**STATE OF NEW JERSEY
OFFICE OF ADMINISTRATIVE LAW
BEFORE HONORABLE IRENE JONES, ALJ**

I/M/O the Verified Petition of Rockland)	
Electric Company For Approval of)	
Changes in Electric Rates, Its Tariff For)	OAL Docket No. PUC 17625-2013N
Electric Service, And Its Depreciation)	
Rates, Termination of the Smart Grid)	BPU Docket No. ER13111135
Surcharge; Establishment of a Storm)	
Hardening Surcharge; and For Other)	
Relief)	
)

**DIRECT TESTIMONY OF CHARLES P. SALAMONE
ON BEHALF OF THE
DIVISION OF RATE COUNSEL**

Schedule CPS- 1 Comparison of Electric Blanket Budget Amounts

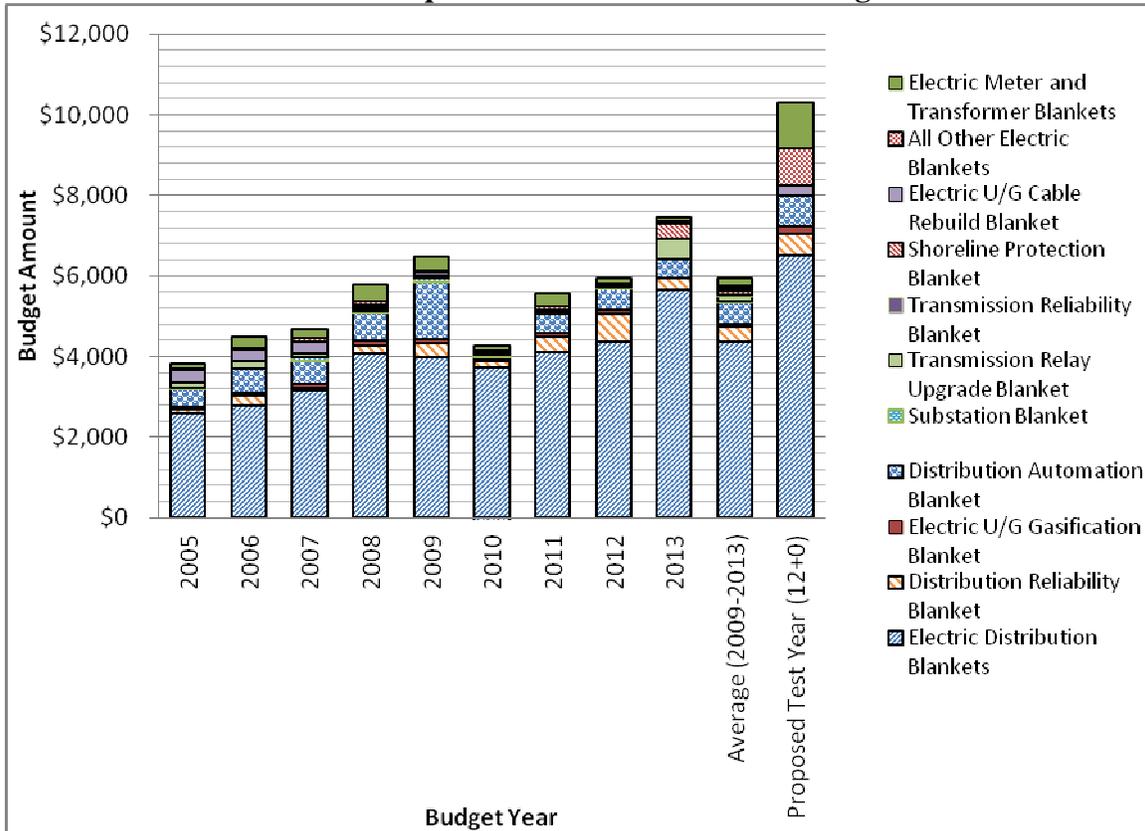
5 **A.** The Company's budgeted electric distribution blankets for the test year differ
6 radically from their historical blanket budget amounts. Schedule CPS- 1¹ below
7 shows the Company's annual blanket budget amounts from 2005 through 2013
8 along with the test year budget and the 2009 through 2013 averages. The
9 Company's overall proposed test year electric blanket spending is 75 percent
10 higher (\$10.2 million versus \$5.8 million) than the Company's 2009-2013
11 average.

1 **Schedule CPS- 2 Comparison of Test Year Budget to Five Year Average**

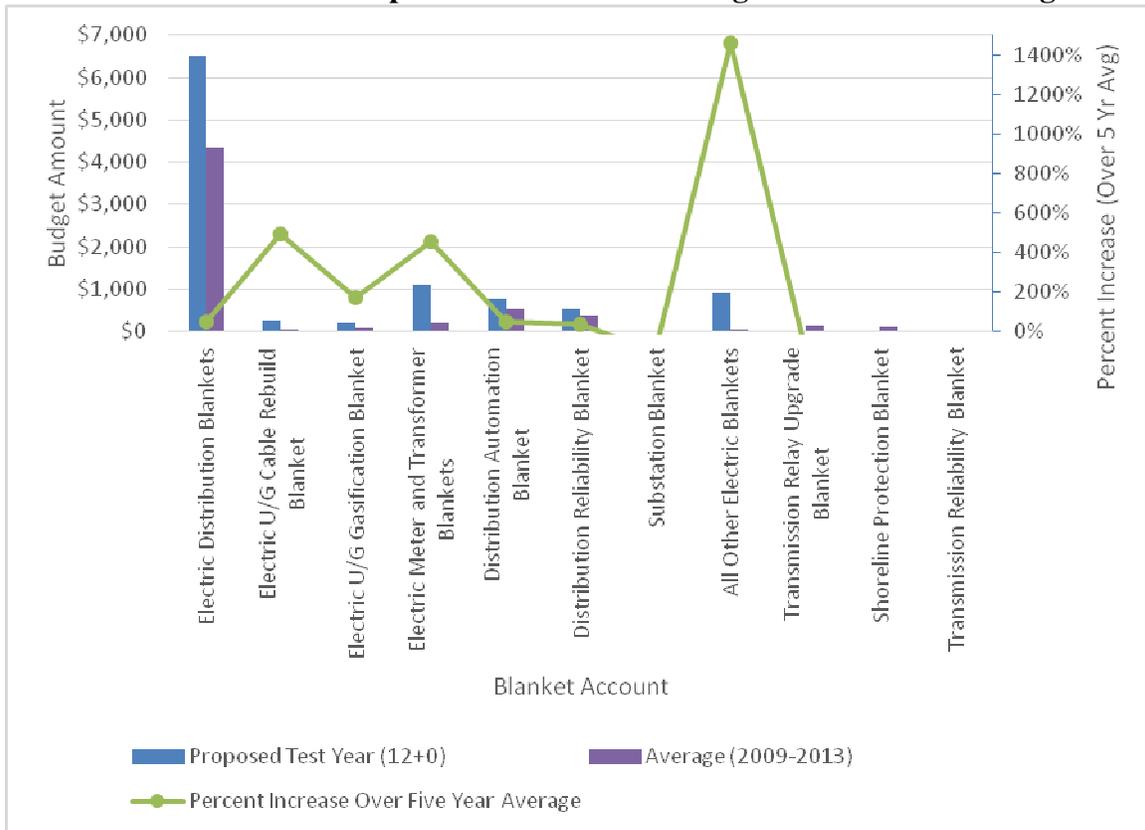
A review of the proposed test year budgets as compared to the 5 year average budget values indicates that a number of budget items are disproportionately higher than the historical average. Schedule CPS- 2 below shows the 5 year average budget amount, the test year budget amount and the percent difference between these two values.

3 The Company has not offered any explanation for these extraordinarily higher
 4 blanket budget amounts.
